**Economic and Social Council**Distr.: General
20 February 2015

Economic Commission for Europe**Inland Transport Committee****World Forum for Harmonization of Vehicle Regulations****Working Party on General Safety Provisions****108th session**

Regulation No. 39 (Speedometer)**Proposal for draft 01 series of amendments to Regulation No. 39
(Speedometer)****Submitted by the expert from the Fédération Internationale de
l'Automobile ***

The text reproduced below was prepared by the expert from the Fédération Internationale de l'Automobile (FIA) proposing further amendments to the proposal submitted by Belgium on performance requirements for the installation of odometers on vehicles (ECE/TRANS/WP.29/GRSG/2015/15). The modifications to document ECE/TRANS/WP.29/GRSG/2015/15 are marked in bold characters.

Model A

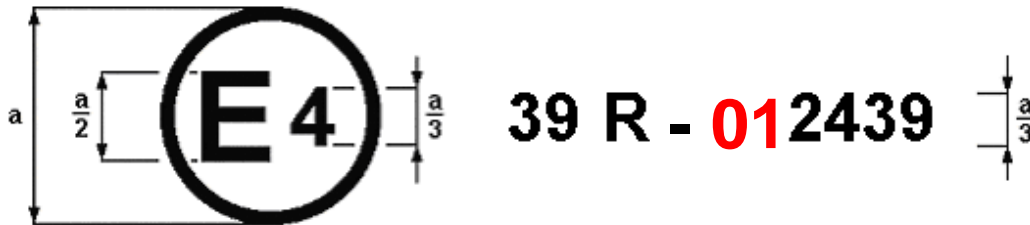
The above approval mark affixed to a vehicle shows that the vehicle type concerned has been approved in the Netherlands (E 4), pursuant to Regulation No. 39. The approval number indicates that the approval was granted in accordance with the requirements of Regulation No. 39 **incorporating the 01 series of amendments**.

Model B

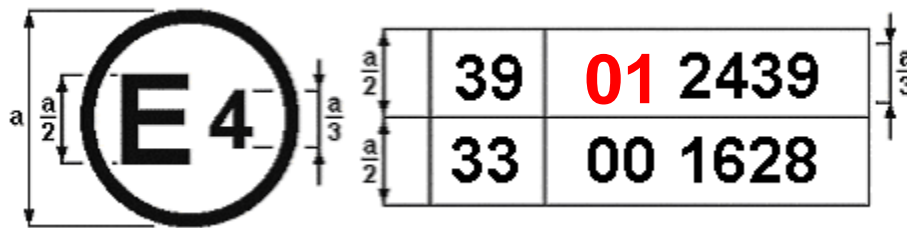
The above approval mark affixed to a vehicle shows that the vehicle type concerned has been approved in the Netherlands (E 4) pursuant to Regulations Nos. 39 and 33.¹ The approval numbers indicate that, at the dates when the respective approvals were granted, **Regulation No. 39 incorporated the 01 series of amendments and Regulation No. 33 was still in its original form**.

Figure 1
Target of Evaluation (System Overview)

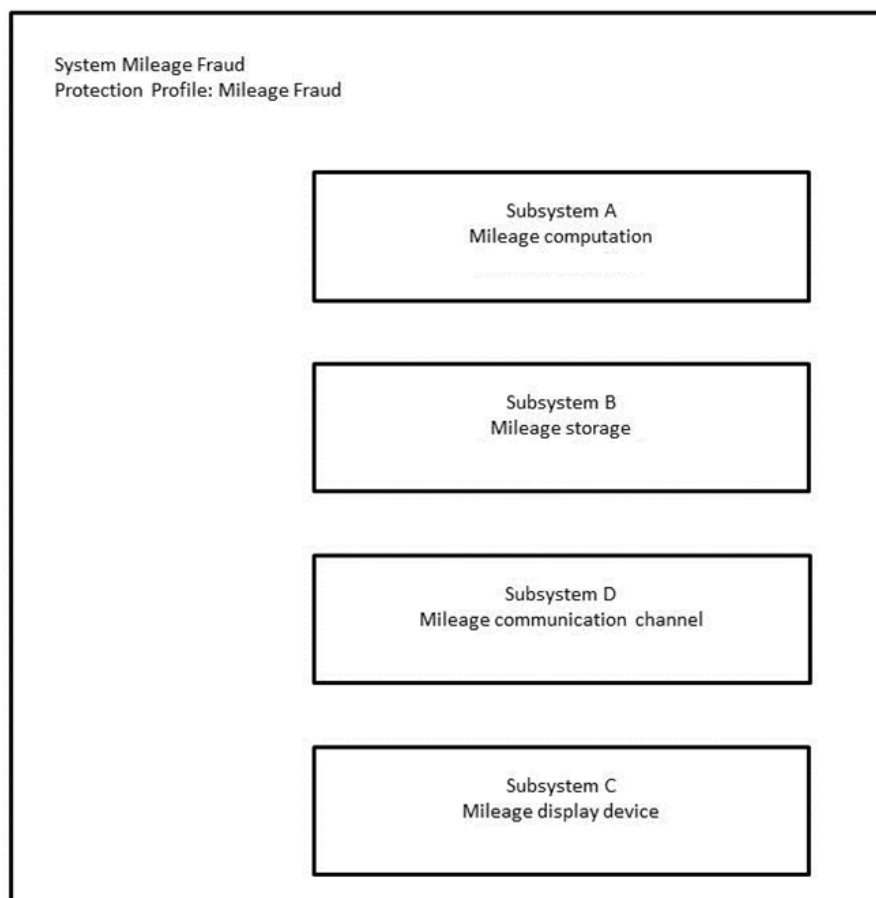
The Protection Profile covers the entire odometer system related to mileage fraud and any relevant use cases encountered during the vehicle's lifecycle. The TOE is thus comprised of subsystems with respect to the Protection Profile. In terms of subsystems and system boundaries from a mileage fraud viewpoint, four subsystems can be identified:

This subsystem is comprised of the communication channel and communication process used to transmit the value of the actual mileage to the display device. This channel as the fourth relevant subsystem of the overall mileage fraud solution has also to be protected by the Protection Profile to prevent "Man in the Middle" attacks. If, for example, the mileage is perfectly accurate and safely stored in the vehicle but the communication between the display device is a form of unencrypted messages over the OBD-port, then an attacker could easily implement a small hardware solution inside the vehicle that accesses the bus, intercepts the request for mileage retrieval and corrupts the answer to the display device. State of the art encryption technology for the communication channel between stored value (Subsystem B) and display device (Subsystem C) will thus be enforced by the Protection Profile.
